PROJECT/SITE OWNER: Maylan Thomas	PROJECT SUMMARY: New Cedar fence and a 7 X 7 shed
PROJECT ADDRESS: 9040 N Mohawk	÷

VILLAGE CODE REVIEW

Bayside ARC Review Page 2 of 3

Drawing Name:
Shed on Survey
Date:
May 5, 2021
Scale:
1/2" = 1'-0"
Page Number:
6

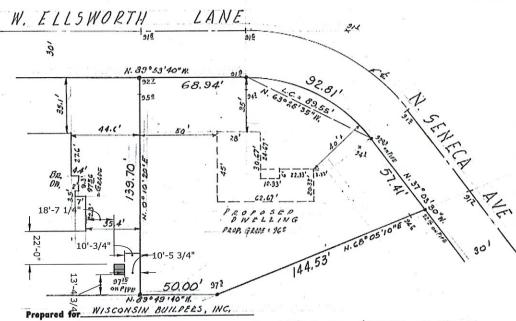
NEW SHED LOCATION DOES NOT COMPLIES WITH VILLAGE CODE.

Sec. 125-91. - "C" residence district regulations.(5)

A rear yard of not less than 20 feet shall be provided for every building, except one of not less than ten feet shall be provided for a building used for or classified as an accessory use.

The rear yard set back is only 8' 7 34" not confirming to the required 10' set back
